**Addendum 1**

ITB# 19-42-207522

Seward Freight Dock: Damage Repairs and Upgrades

Addendum number 1 is issued for Questions and updated drawings/ plans set.

TITLE:  
**Torsion Plate Assembly and Details  
for 24"ø x 0.500"t Pipe Pile**

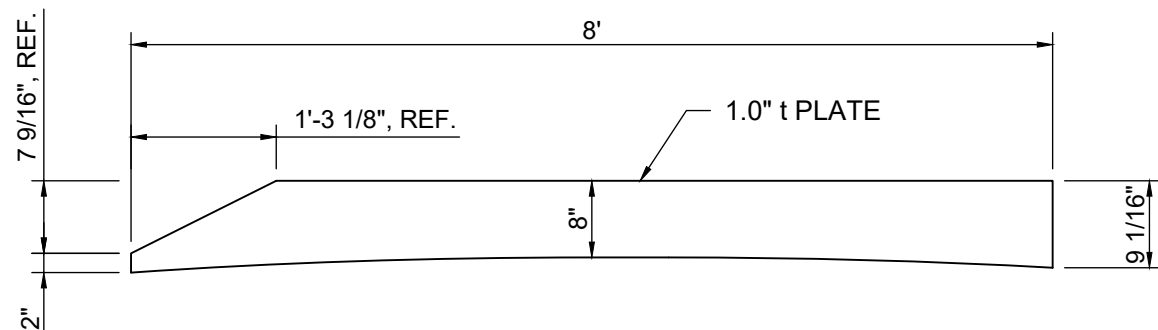
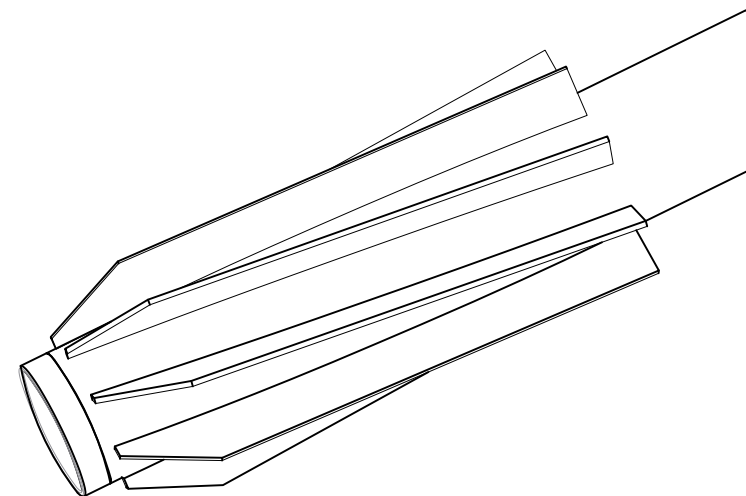
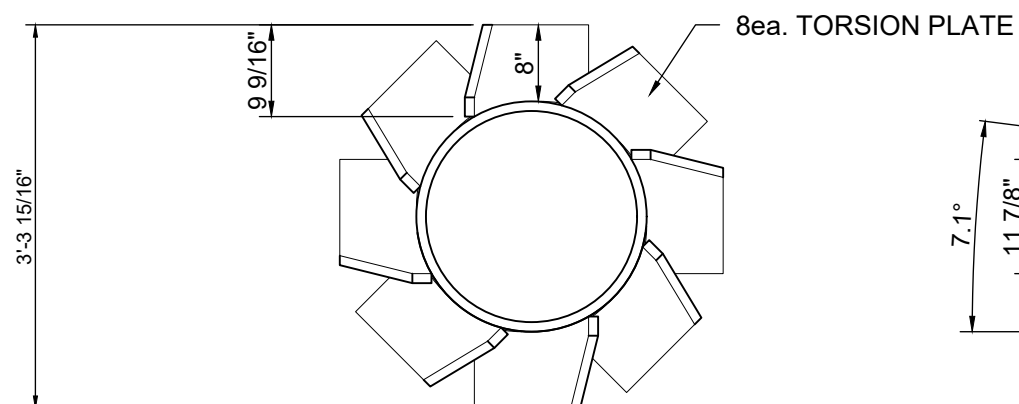
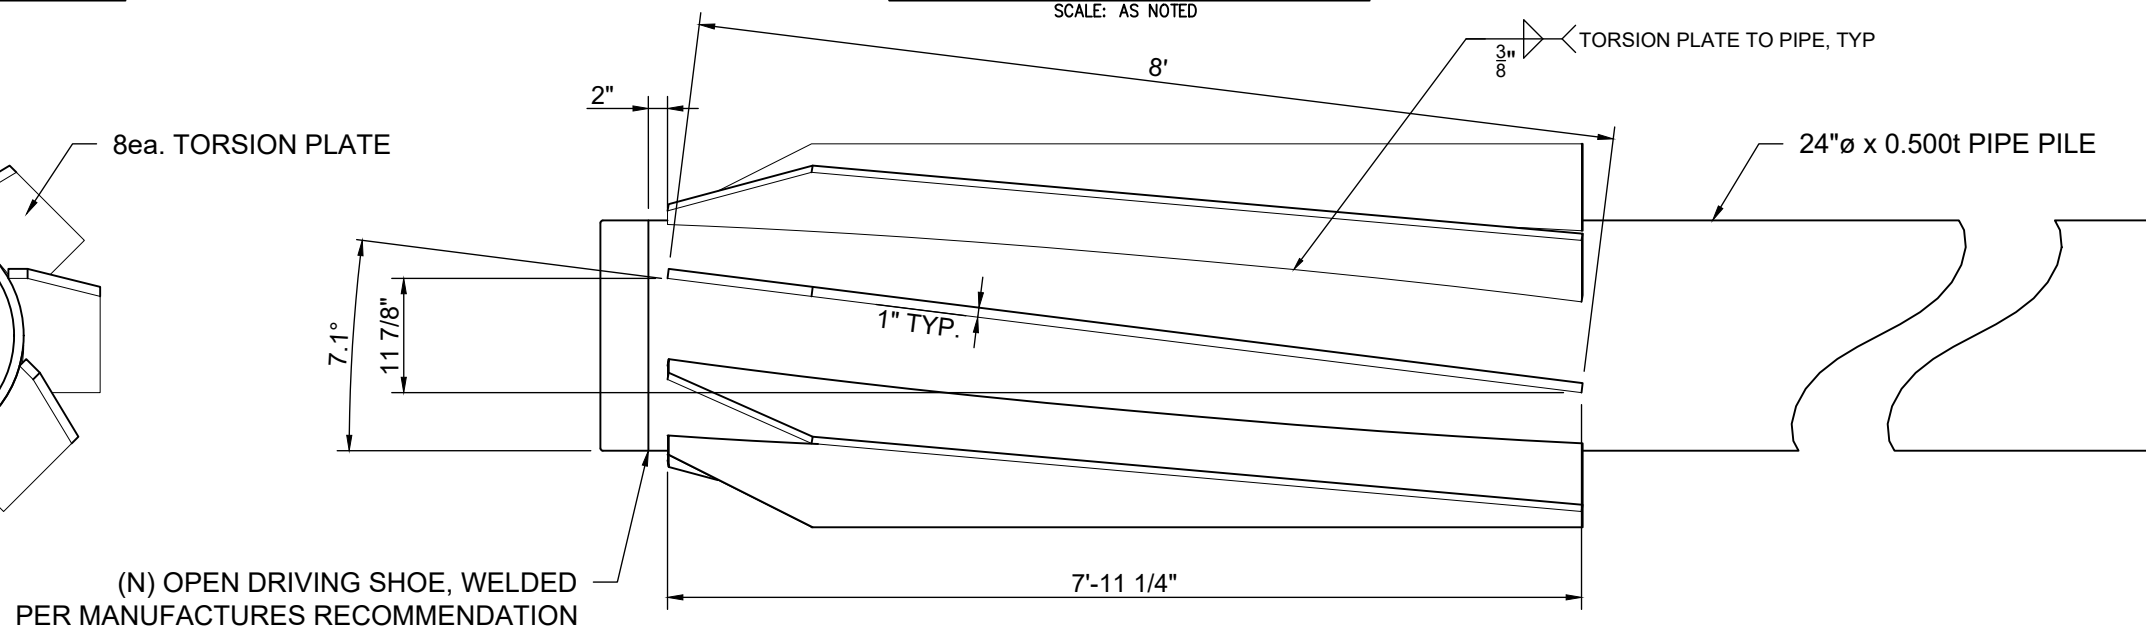
3. Are the torsion plates going to be fully fabricated and provided by the ARRC?
  - a. The eight (8) torsion plates will be provided by the ARRC. The Contractor shall be responsible for affixing the plates to the pipe pile in the field.
